# TZT-701 / SMT-700 Replacement check sheet RRP Pricing Shown

The SMT-700 or the temperzone branded TZT-701 are no longer in production. There is no direct replacement however there are some alternatives products that are suitable replacements.

## TZT-701 / SMT-700 Replacement Options

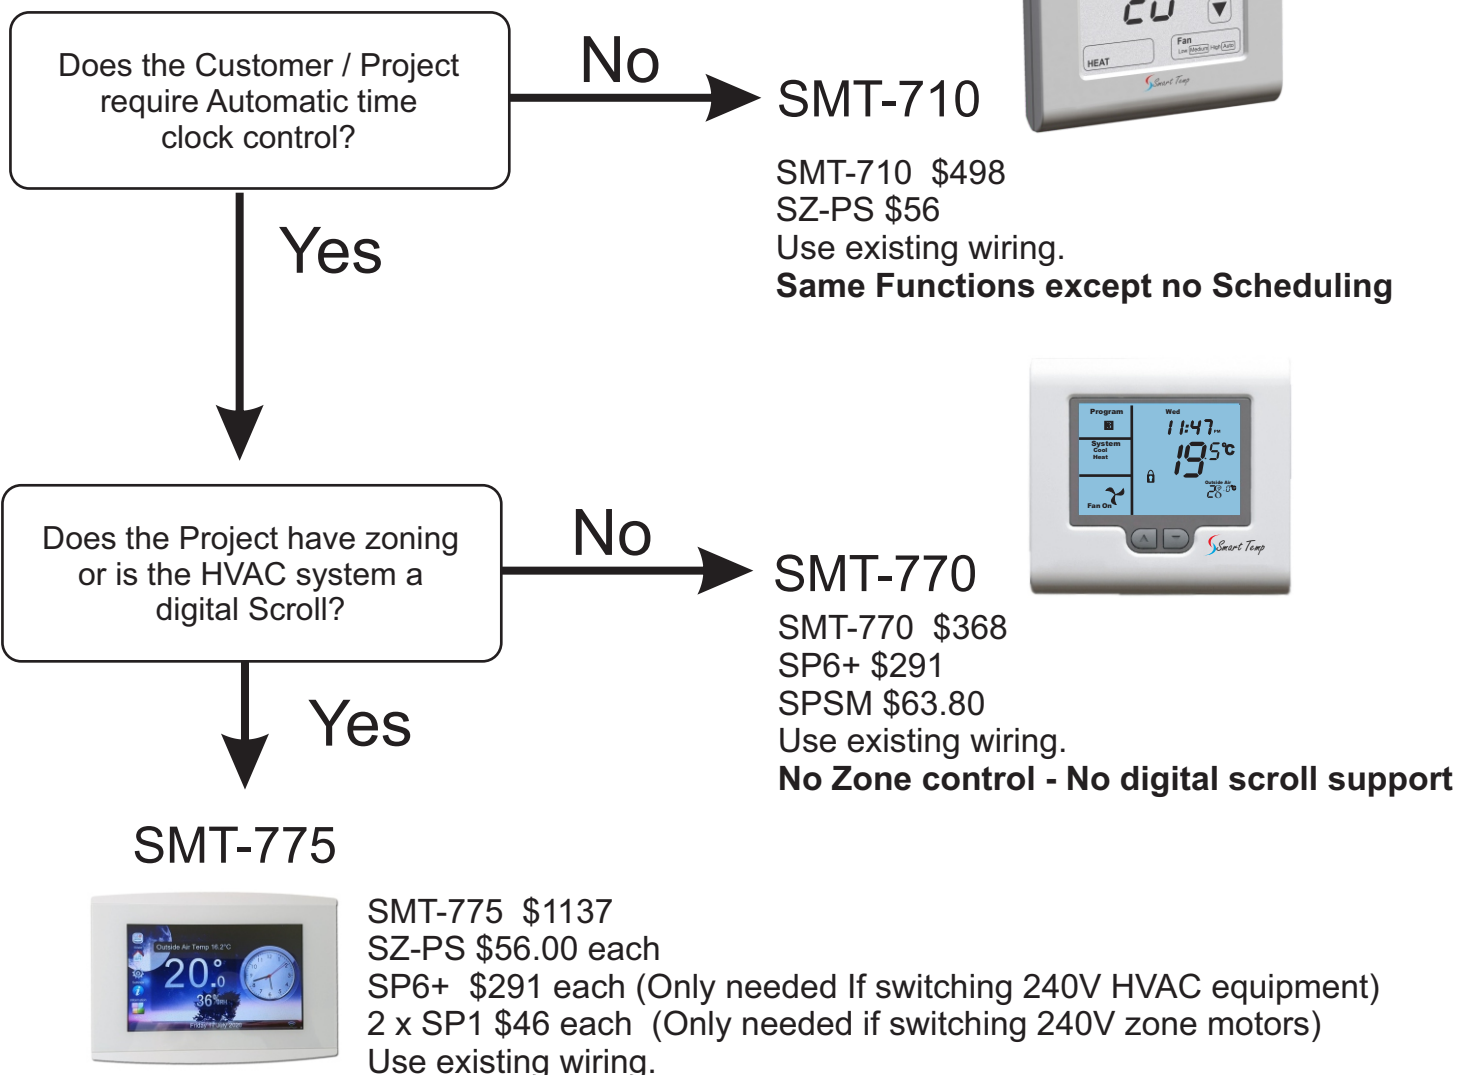
Note, any solution you choose will require the wall controller and the Unit Control Card in the HVAC unit to be replaced.

The SMT-770 / TZT-701 had several link wires that joined the G-In, Y-In and W-In terminals to split voltages between heat cool and fan. The replacements offered below have internally linked so **external links are NOT required.**

Customised wiring diagrams can be supplied for each option upon request
